# 1200-1340 OLD BAYSHORE HIGHWAY PROJECT

## Response to Comments Document

Prepared for  
City of Burlingame

February 2024

**Revised Figure 3-4**  
Proposed Ground Level Site Plan

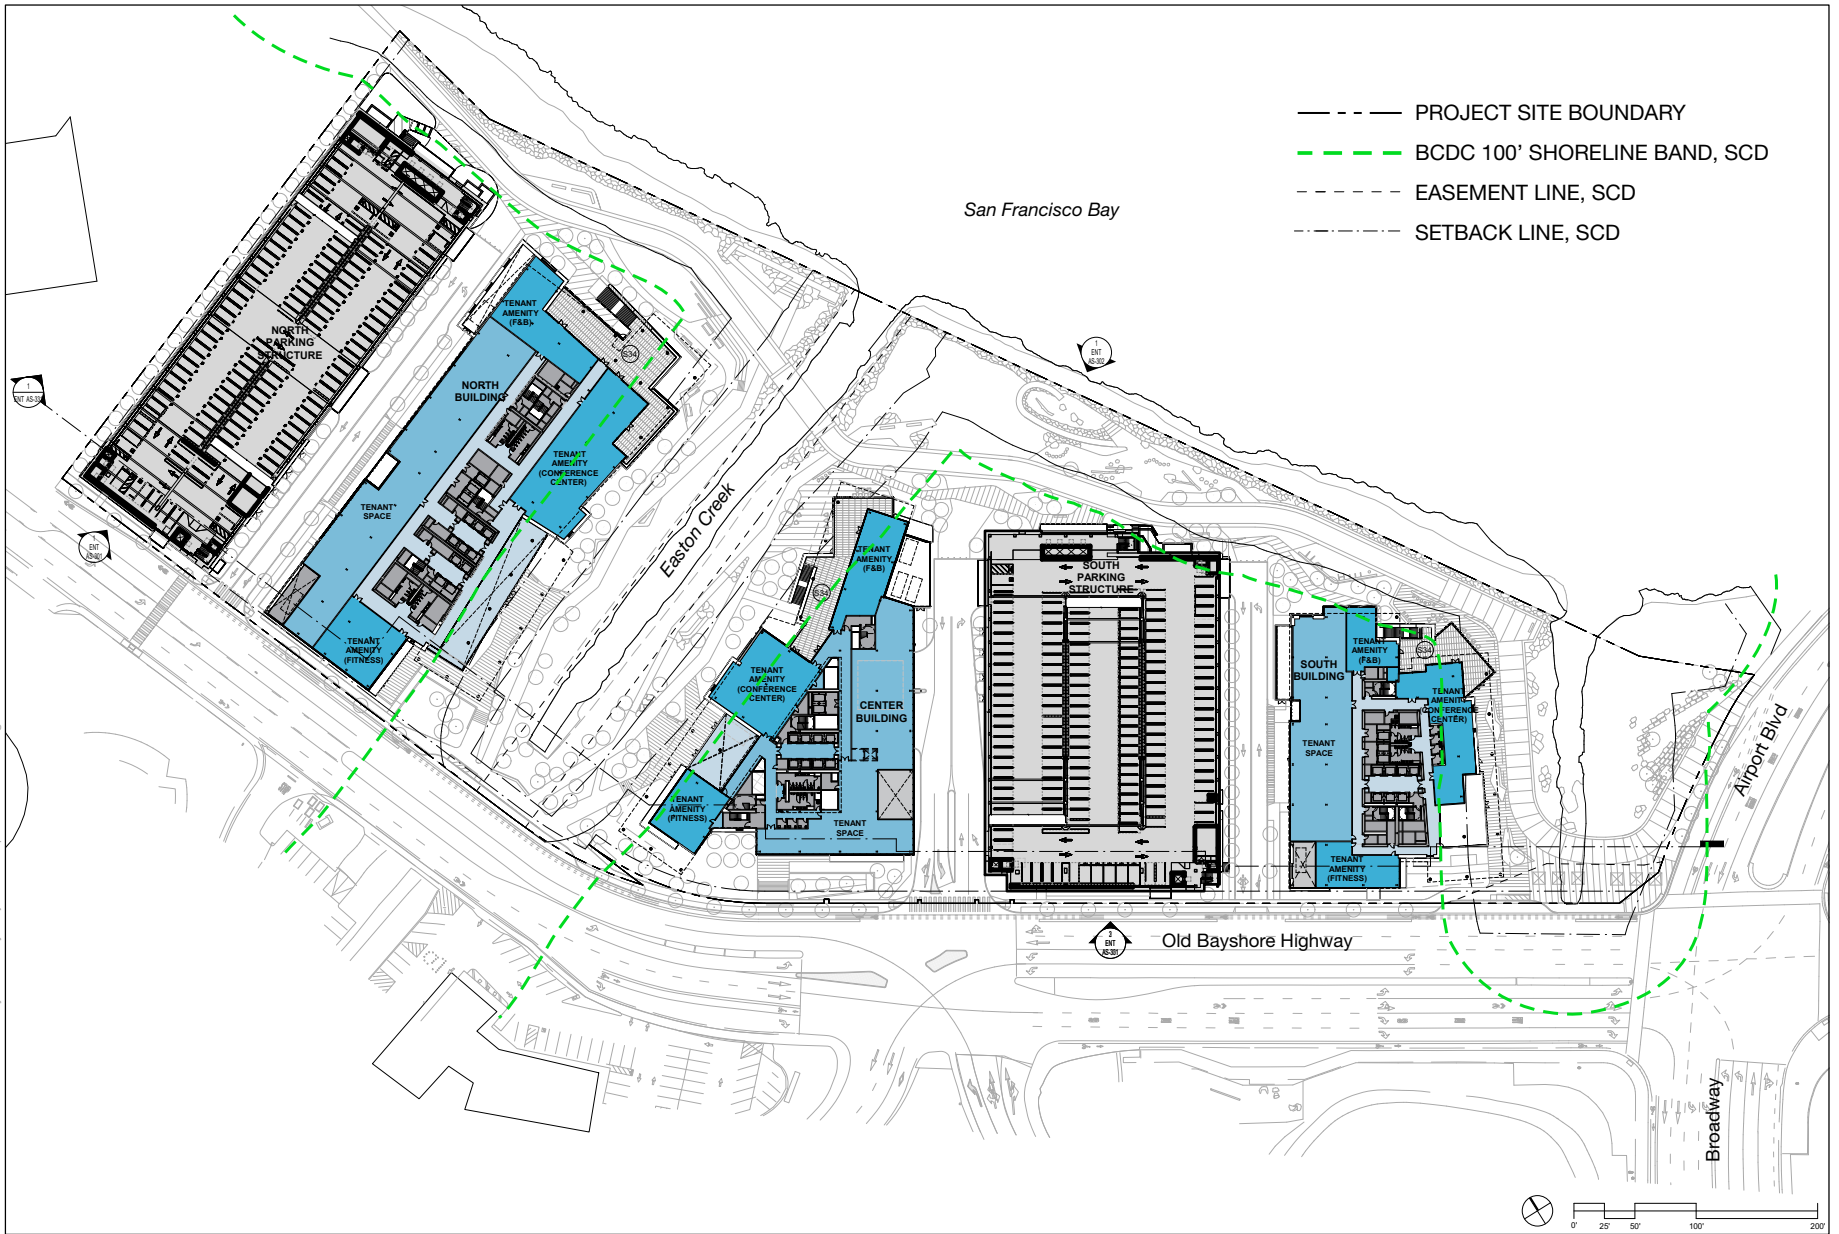
A-BCDC-3 The commenter indicates the BCDC jurisdictions depicted in Draft EIR Figures 3-4 through 3-7 appear to be from an older understanding of its jurisdictional limits. The commenter indicates the notes in Figure 3-4 are not legible in the DEIR PDF, and should be made larger and more clear. The commenter requests at least one figure in the EIR with current information and ensure that it is clearly labeled.

Figures 3-4 through 3-7 have been revised to reflect the current BCDC 100-foot shoreline band; labels and titles for jurisdictional limits on the figures have been made clearer; and Figure 3-4 is enlarged from an 8½ x 11-inch to a 11 x 17-inch dimension. Please refer to Chapter 4, *Revisions to the Draft EIR*, of this Response to Comments document for the revised figures.

Figures 3-4 through 3-7 presented on the following pages have been revised in response to Comment A-BCDC-3.
